TECHNICAL BULLETIN		Mfg: FORD
	March 2006	Model: TRUCK
	TB 2201R	Liter: 6.0L
		V I N: P
		Year: 02-09

Cylinder Head Installation For
2003-2005 Ford 6.0L Diesel Engines

Bulletin Diagram: FIGURE 1. CYLINDER HEAD BOLT TORQUE SEQUENCE - CYLINDER HEAD

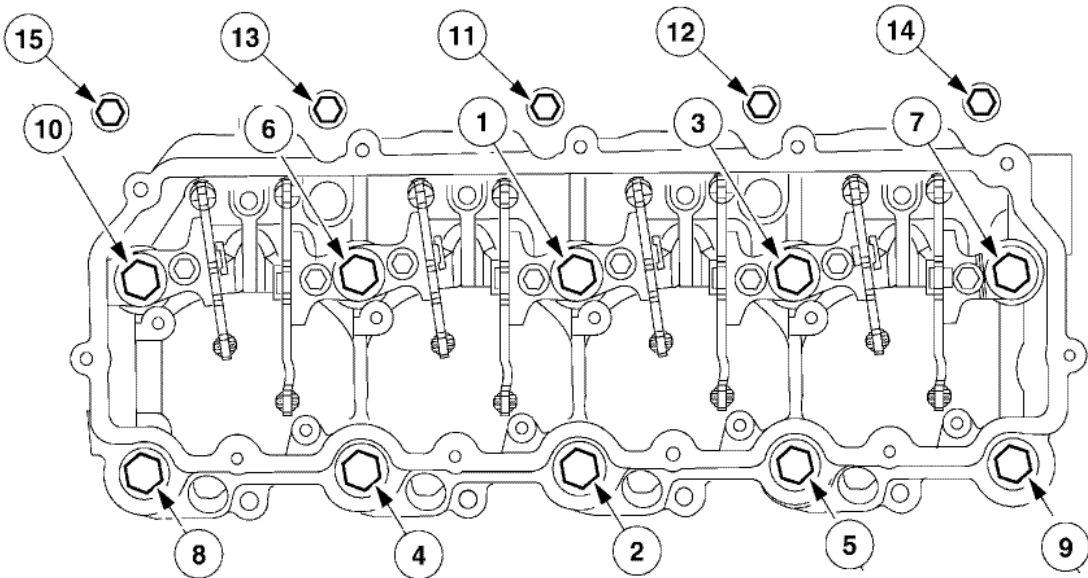
The AERA Technical Committee offers the following information regarding cylinder head installation for 2003-2005 Ford 6.0L diesel engines. This bulletin is being revised to reflect changes to the head bolt torque sequence originally published. This engine utilizes fifteen bolts to secure each head to the cylinder block, ten M14 and five M8 bolts. Before installing the cylinder heads, it is important to obtain new M14 head bolts; the M8 bolts may be reused if they're undamaged.

1. Torque lubricated bolts in the sequence numbered 1 through 10 to 65 ft/lbs (88Nm).
2. Torque all bolts in sequence numbered 1 through 10 to 85 ft/lbs (116 Nm).
3. Torque all bolts in sequence numbered 1 through 10, clockwise 90°.
4. Torque all bolts in sequence numbered 1 through 10, a second time clockwise 90°.
5. Torque all bolts in sequence numbered 1 through 10, a third time clockwise 90°.

1. Torque all M8 bolts in the sequence numbered 11 through 15 to 18 ft/lbs (24 Nm).
2. Torque all M8 bolts in the sequence numbered 11 through 15 to 23 ft/lbs (31 Nm).
